# **Missouri River Bed Degradation Feasibility Study Technical Report, Missouri and Kansas**

## **Agency Technical Review**

Review of Draft Technical Report

**Subject:** Review report for review of the Draft Technical Report for the Missouri River Bed Degradation Feasibility Study, March 2017 through June 2017, Kansas City District.

Figure 2. Modeled vs. measured bed elevation change from 1994 to 2009. (Figure 7-2 in the technical report)

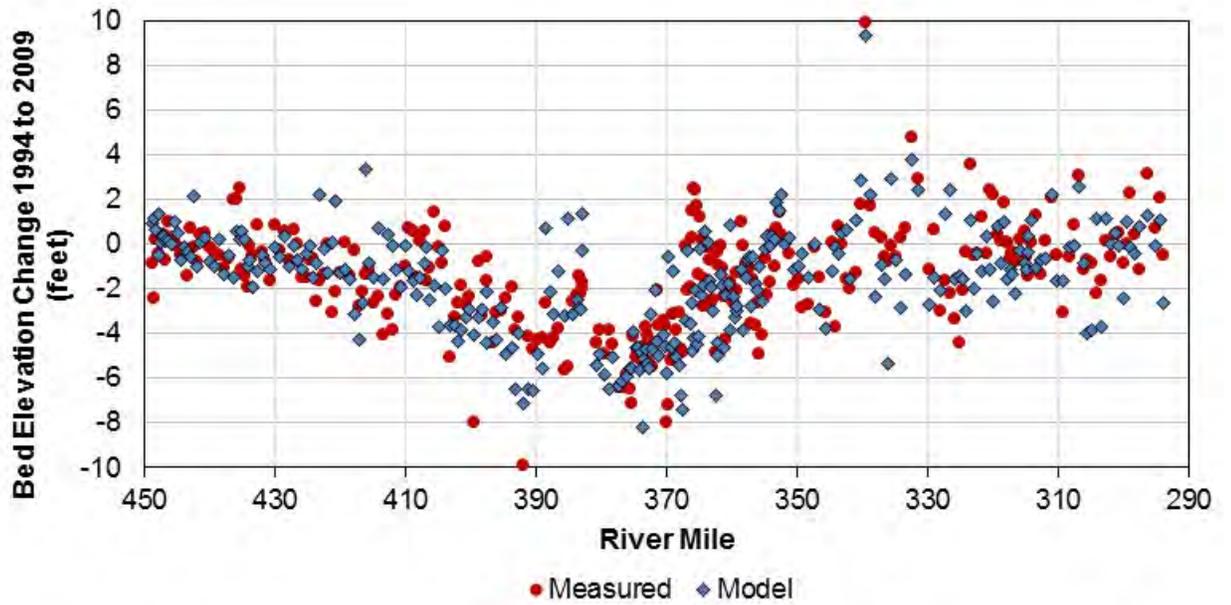
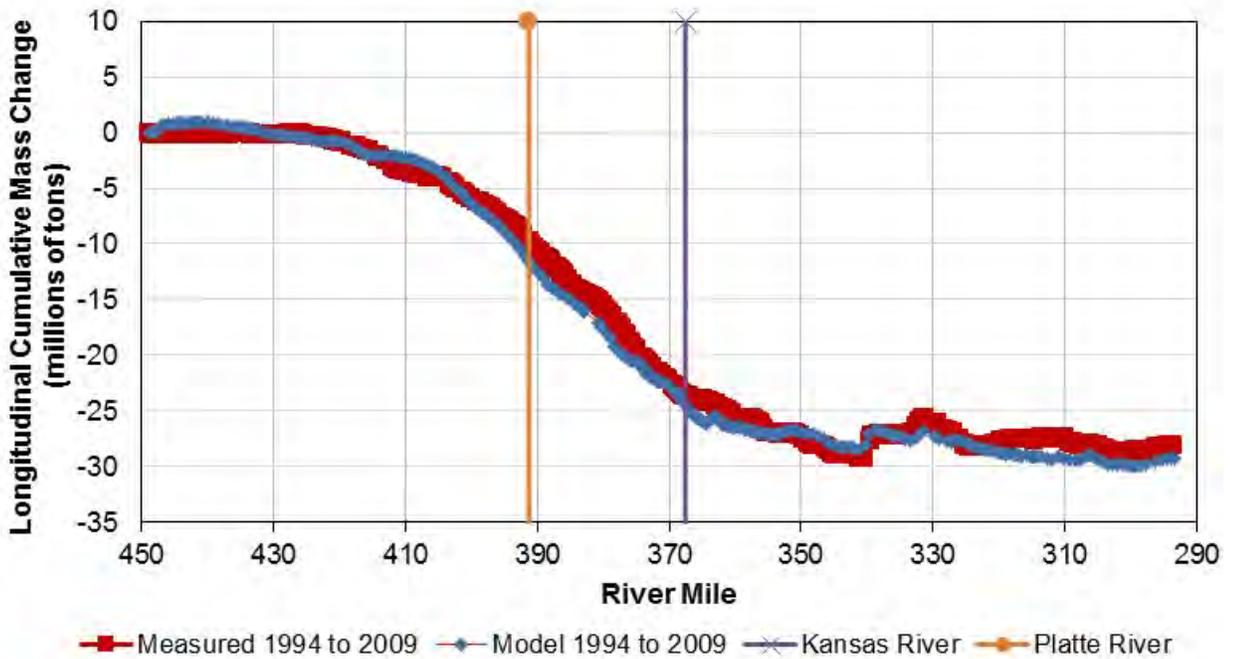
- 3.9 Section 2.4 - The report states that 52 million tons (MT) of sediment was extracted in the Kansas City reach from 1994 to 2009. Figure 9 (page 11) shows for the ’94 – ’09 time period approximately 20 MT of bed material loss from St Joseph to the RM 380, the upstream limit of dredging. The figure shows approximately 10 MT of bed material loss through the dredging reach from RM 380 to RM 355. Downstream of the dredging reach, only 5 MT of bed material loss is observed. Accordingly, it is apparent that dredging had nothing to do with the 20 MT of bed material loss upstream of RM 380. The analysis, as presented by the MBM, begs the question of why there is actually less degradation through and downstream of the dredging reach than what is observed upstream.

3.9 What occurs in one segment of the river can affect both upstream and downstream segments. The model includes dredging at the correct locations, including dredging in the Kansas City metro area and upstream of Kansas City in the St. Joseph metro area. During the principal calibration period (1994-2009) the majority of commercial dredging took place in Kansas City. No attempt was made to implicate dredging or any other particular cause during model setup. Rather, realistic inputs and model parameters were selected and the model was calibrated to reproduce observed river behavior. The measured data indicates that from 1994 to 2009, the majority of the degradation did occur in Kansas City, where and when dredging was highest. The model reproduces this behavior (see Figures 2 and 3 below).

Figure 6. Example of modeled vs. measured water surface elevation at the Kansas City Gage from 1994 to 2002 (from Figure 7-1 in the technical report.)

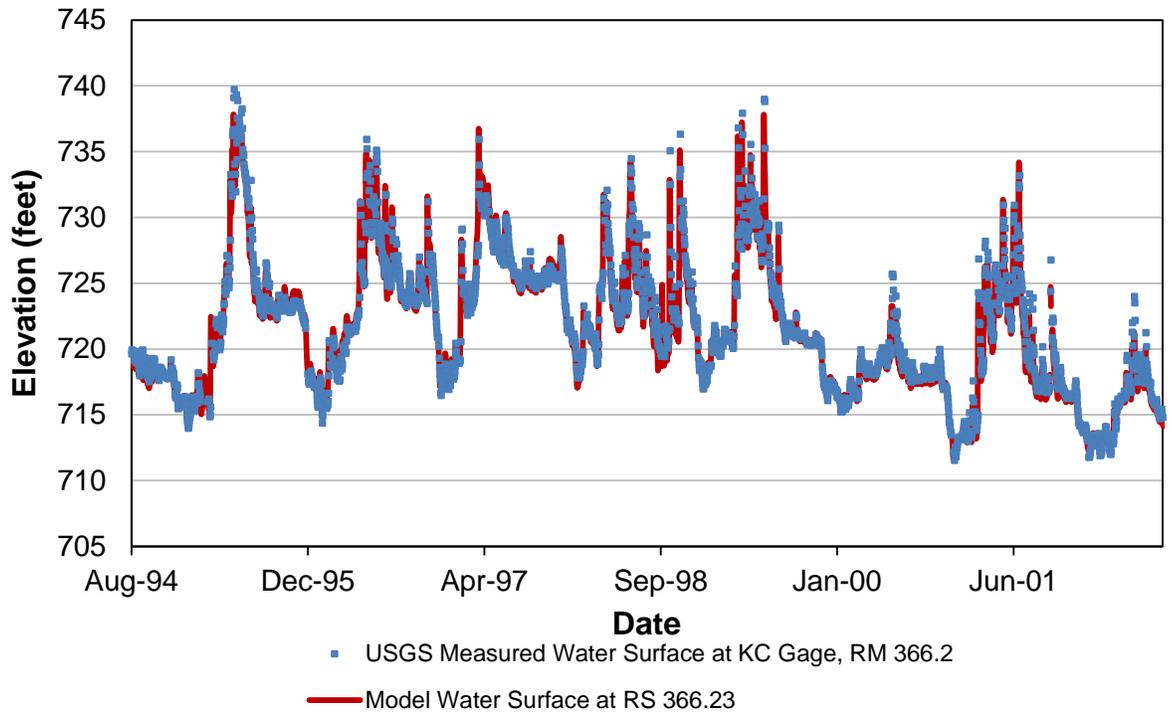
- 3.31 General. A primary purpose of the development and application of the MBM is to quantify changes in the low water construction reference plane (CRP) over time due to channel degradation. No such comparison of the computed CRP over the calibration time period of 1994 thru 2011 is provided, although measured changes in the CRP throughout the study reach are provided in Figures 7 and 8 of the MBM calibration report.

4.5 The model output is compared to USGS stages at low, medium, and high flows. Graphs and analysis of how well the model water surface elevation reproduces USGS measured elevations is provided in Appendix B. One example is provided in Figure 6, below.
